CITY OF ALBUQUERQUE

**RE: Chick-fil-A at Gibson
1600 Gibson Blvd SE
Requested for 30 Day Temporary C. O. - Accepted
Engineers Stamp Date 7/29/15 (M15D012C)**

DRAINAGE AND TRANSPORTATION INFORMATION SHEET

SHEET TITLE
GRADING PLAN

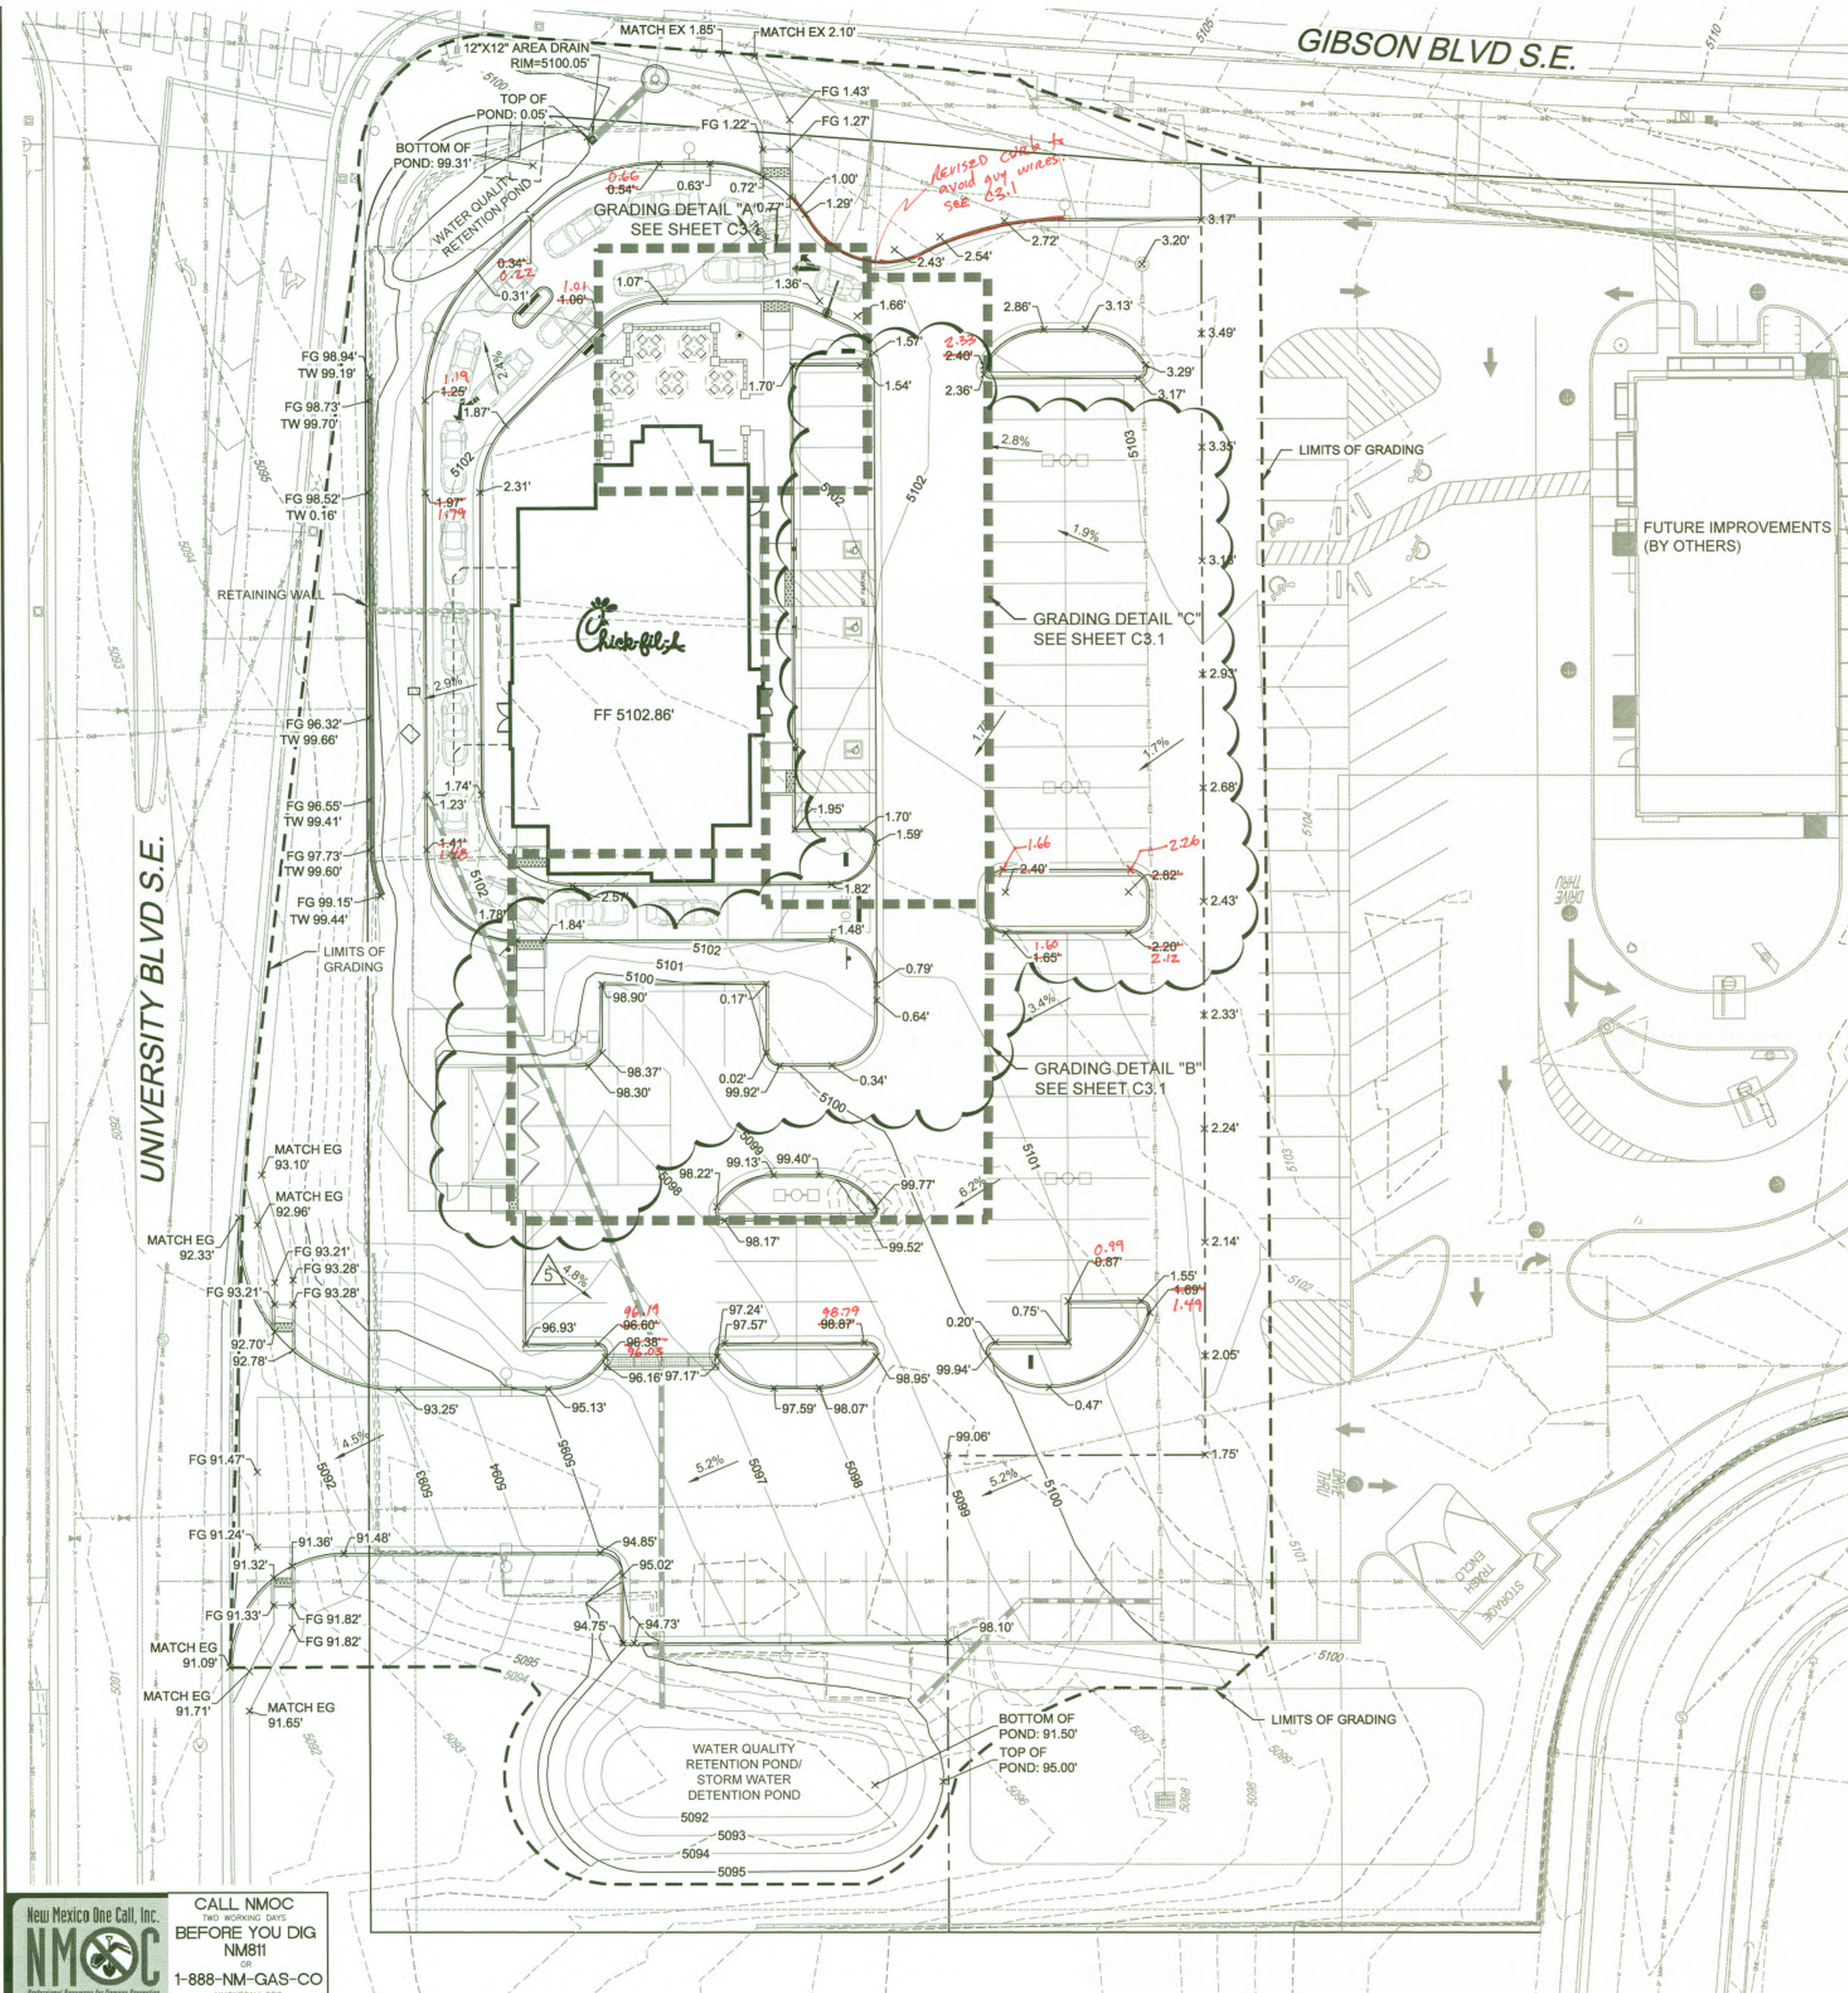
- The pond on the south side must be completed.
 - The drain in the dumpster must be cut at grade and a drain placed over it.
 - The 12" x 12" area drain on the NW corner must be cut and grate placed over it.
- An inspection by our office will need to take place after plan is provided.
